Product Change Notification

Document number: RVD002-74

This notice is to inform our customers of a PCB change that is being implemented for the entire HDMI 7.0" product line.

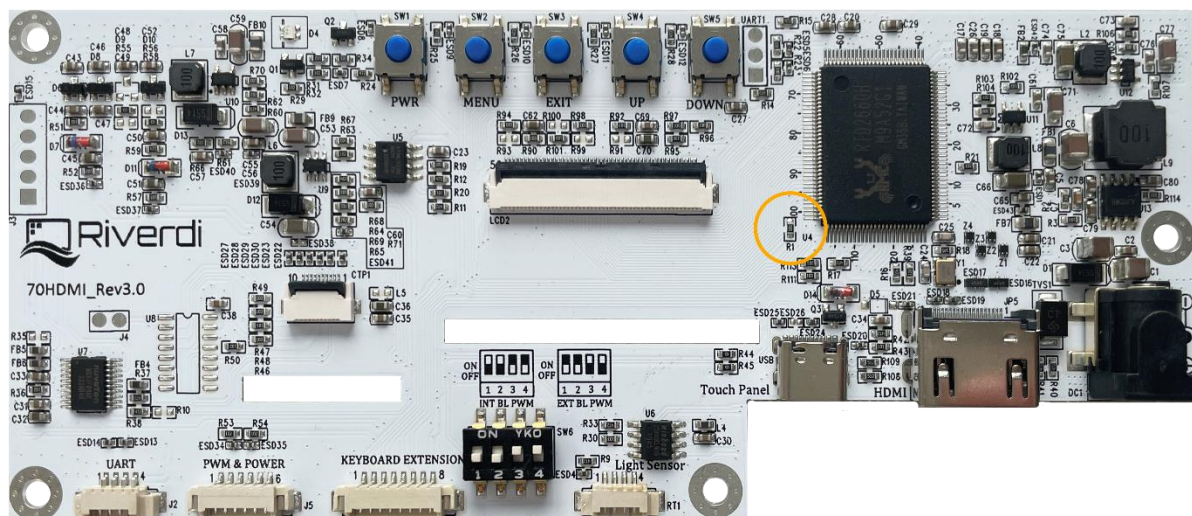
The new PCB has a new added resistor R1 (100 Ohm) to the pin DCLK of RTD2660H.

Please refer to the image below for further information.
